# Detailed Site Plan Dash-In Bowie

# DSP-22016

SUBJECT: Detailed Site Plan DSP-22016  
Dash-In Bowie

# SITE PLAN

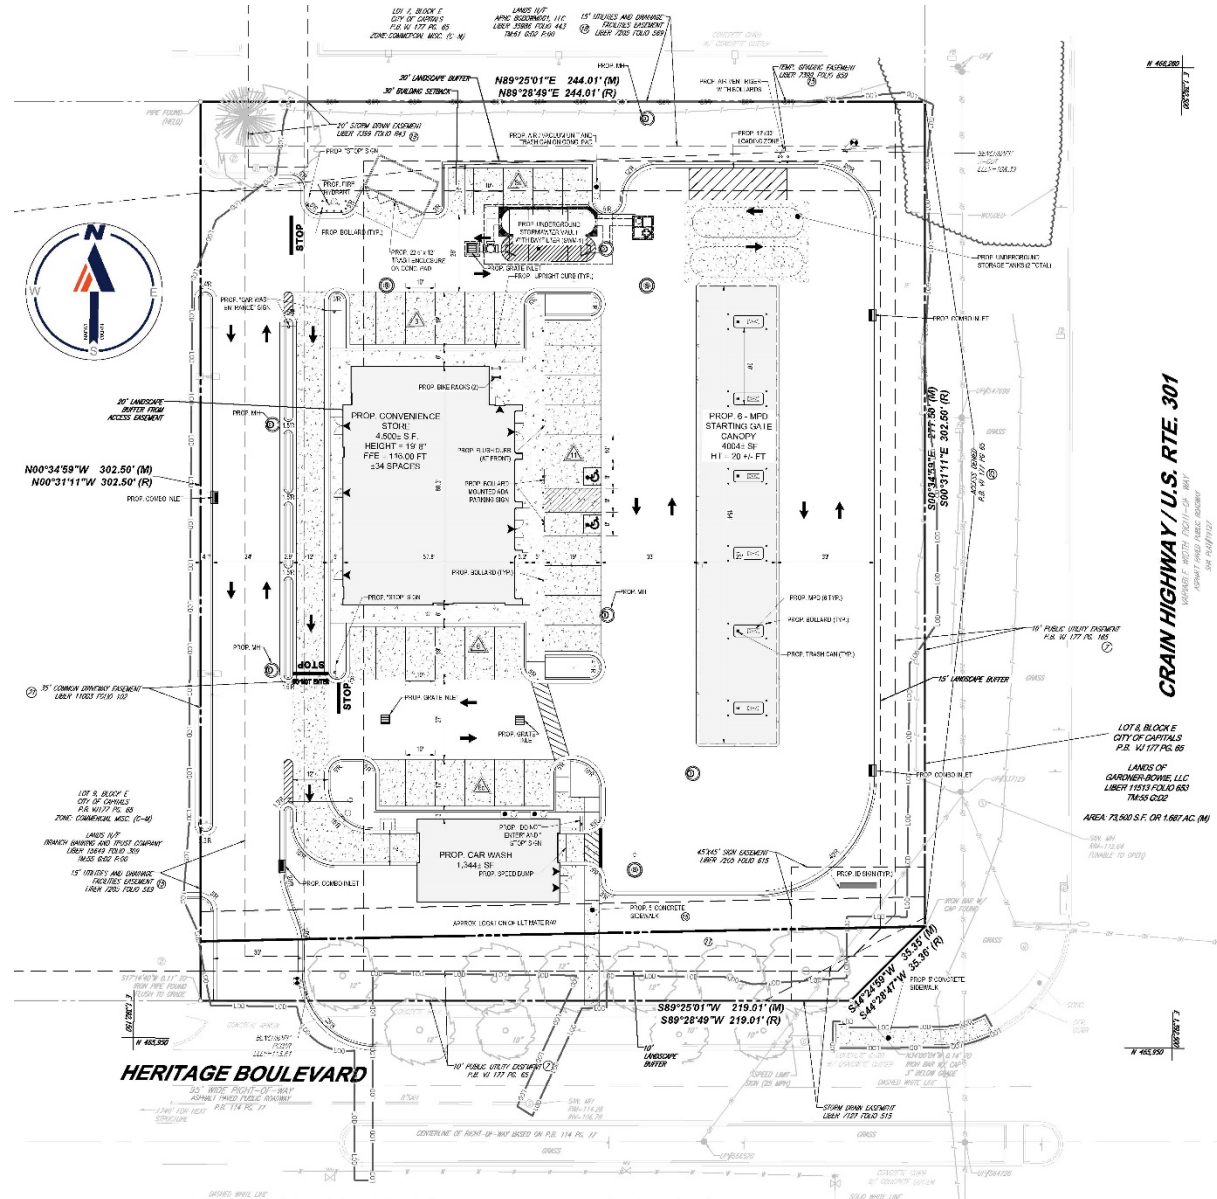
- b. Revise General Note 12 on Sheet 1, and Standard Note 25 on Sheet 4, to include Preliminary Plan of Subdivision 4-95119.
  - c. Provide the dimensions for the car wash on Sheet 4.

- d. Provide the setback for the twin pole pylon sign on Sheet 4.
  - e. Provide at least one electric vehicle charging station on-site for public use.

- f. Provide the required and proposed number of Americans with Disabilities Act parking spaces in the parking tabulation on Sheet 4.
  - g. Provide a note for the asterisk in the parking tabulation on Sheet 4.

- m. Provide dimensions for architectural elevations, including building widths and measurements for major features, such as entrances.
  - n. Modify the site layout to allow for a 30-foot driveway width from the site access point on Heritage Boulevard, to the proposed intersection with the east/west drive aisle to the south of the proposed building. The exact design shall be evaluated and accepted by the Transportation Planning Section.

1. Add the dimensions for the carwash to the site plan, Sheet DSP-4.
2. Add price sign setback to the site plan, Sheet DSP-4.
3. The Permit Review Section offers no further comments on this development application.

# LANDSCAPE PLAN

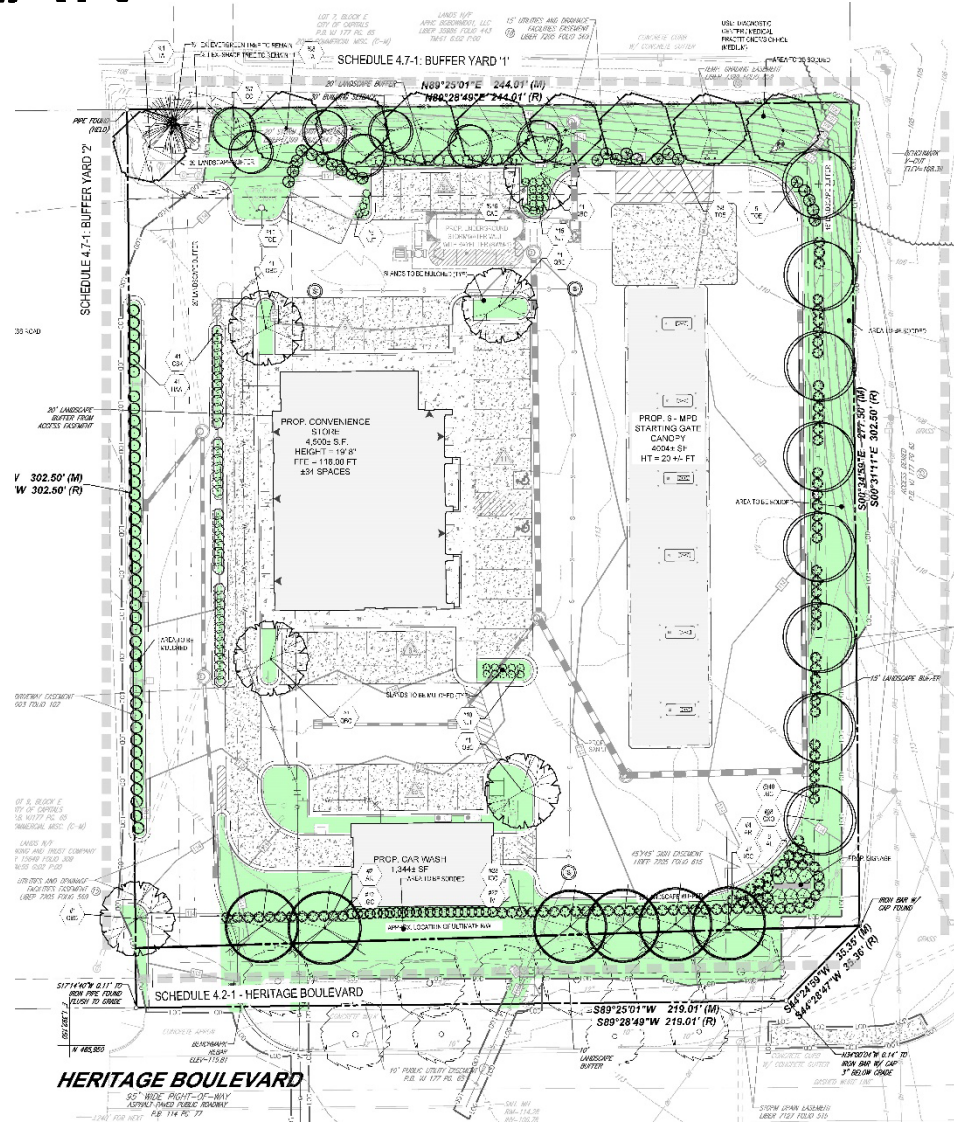
The landscape plan provided is acceptable, subject to two conditions. These conditions have been added in the Recommendation section of this technical staff report. The proposed conditions revise the native and shrub species to 100 percent native, as conditioned by the City of Bowie, and to adequately screen the proposed loading space from US 301 with additional shrubs and groundcovers.

- h. Revise Standard Note 20 on Sheet 4 to indicate the correct companion application number.
  - i. Provide 100 percent native shade trees and shrubs on-site, and revise Landscape Schedule 4.9 accordingly on Sheet 9.

- j. Provide additional shrubs and groundcovers to adequately screen the proposed loading space from US 301 (Robert Crain Highway).
  - k. Provide a signage chart stating the required maximum and provided signage amounts.

# FRONT ARCHITECTURAL ELEVATION (EAST)

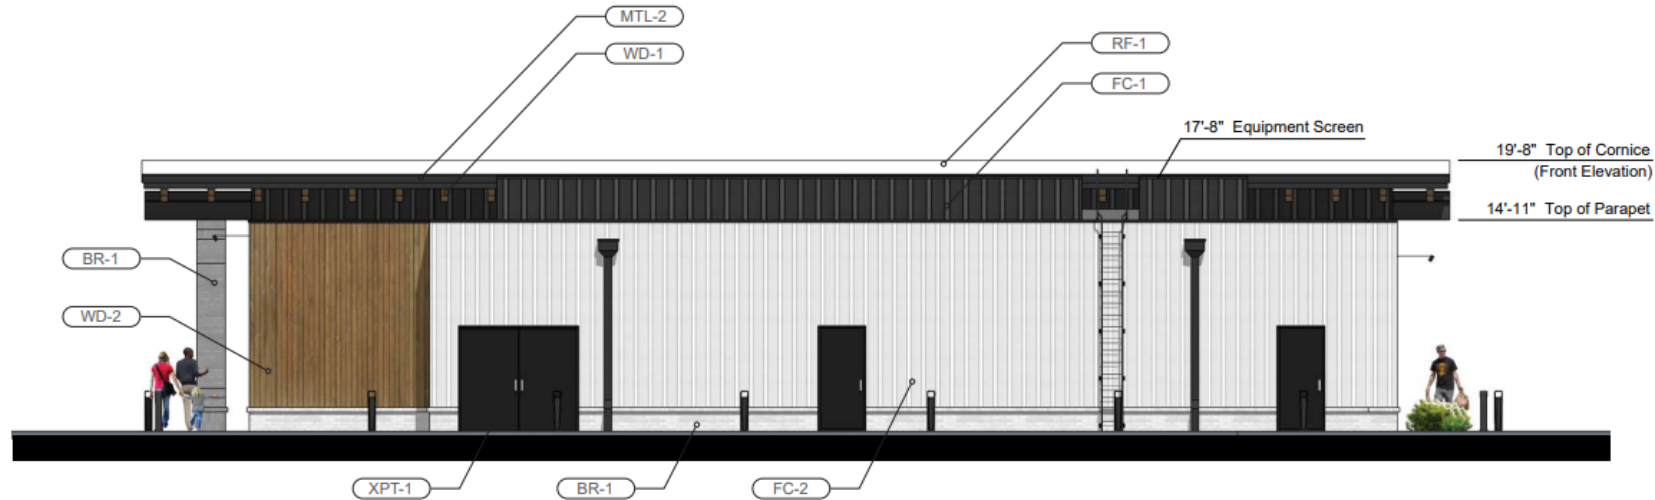
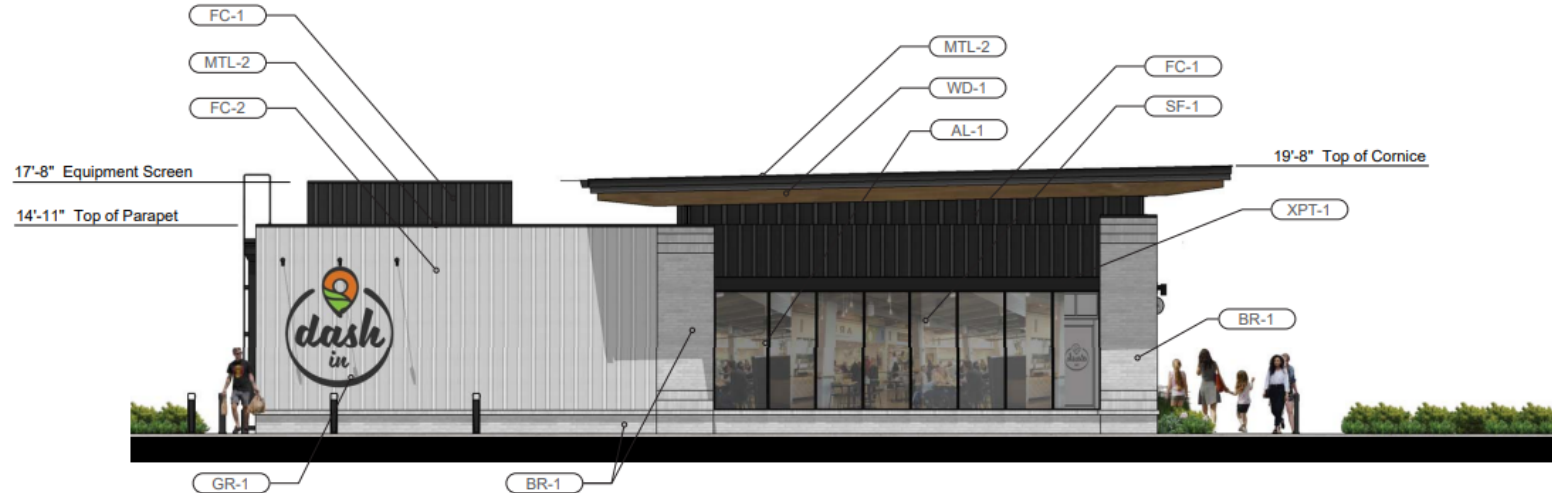
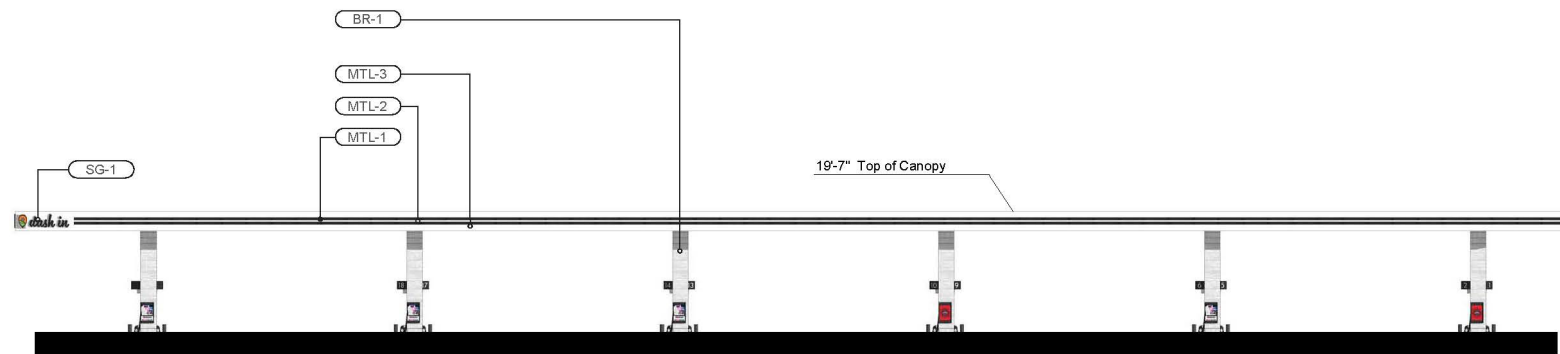
- l. Provide cardinal directions for all architectural elevations.

# TRUCK TURN EXHIBIT Cont...

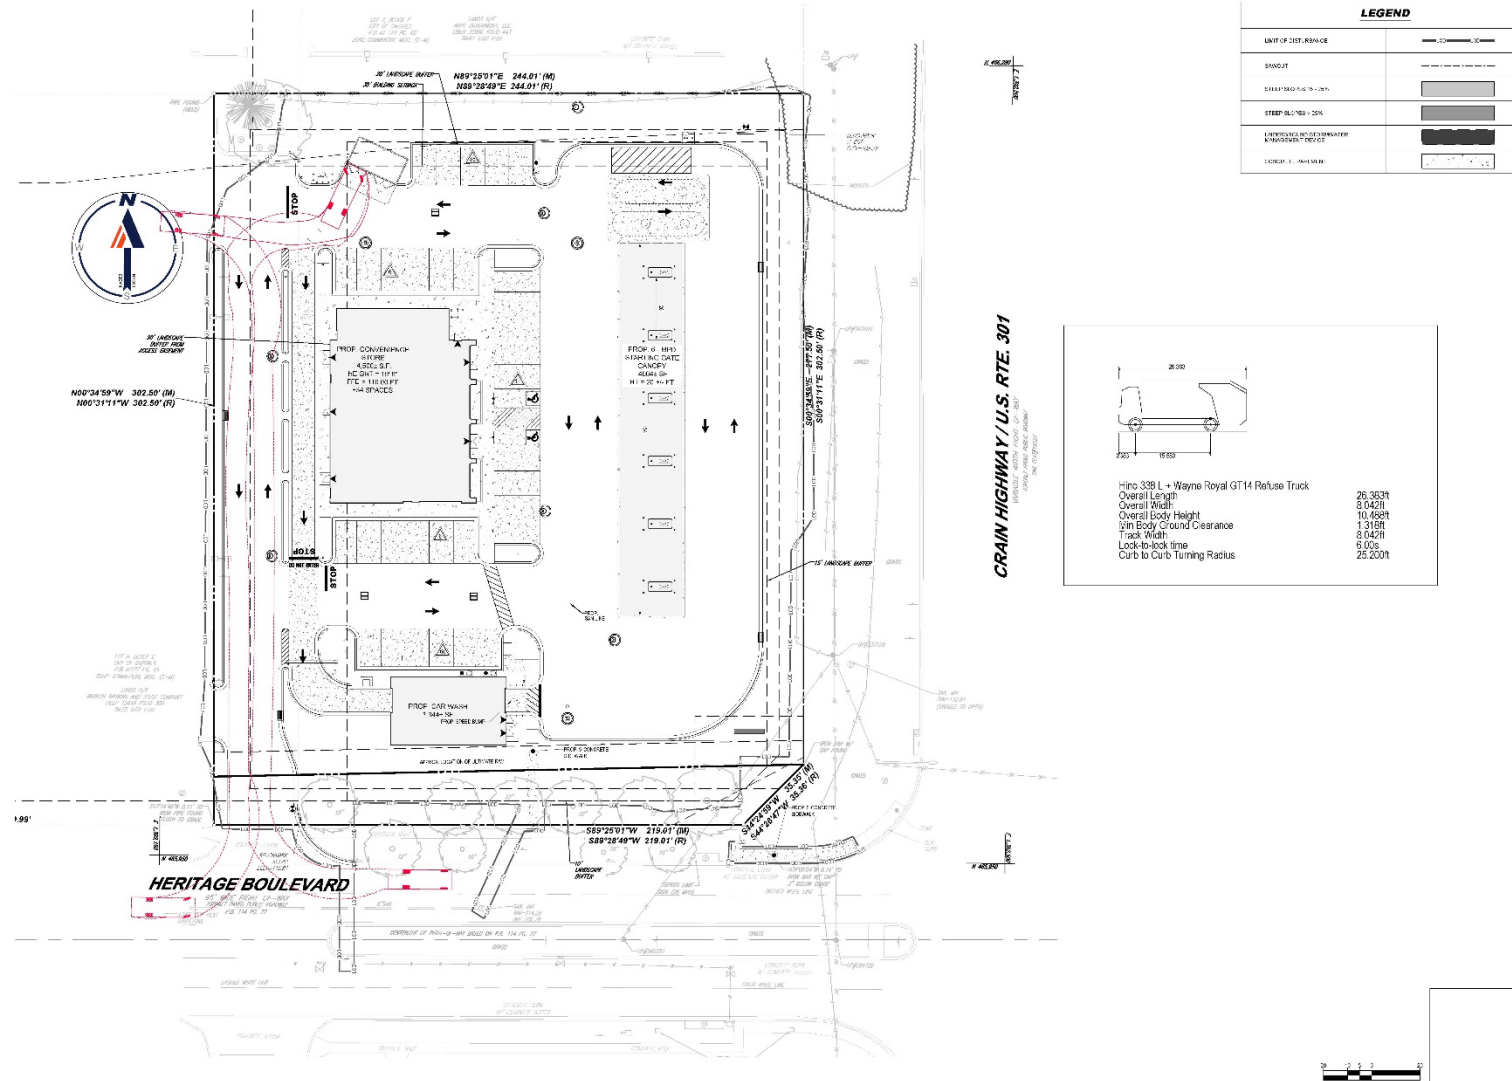
A truck-turning plan was submitted as part of the DSP application to demonstrate on-site truck turning movements with the appropriate design classification for the site. A condition has been included herein, to revise the truck turning plans to not conflict with oncoming traffic lanes.

- o. Revise the truck turning plans to not conflict with oncoming traffic lanes, which will be evaluated and approved by the Transportation Planning Section.
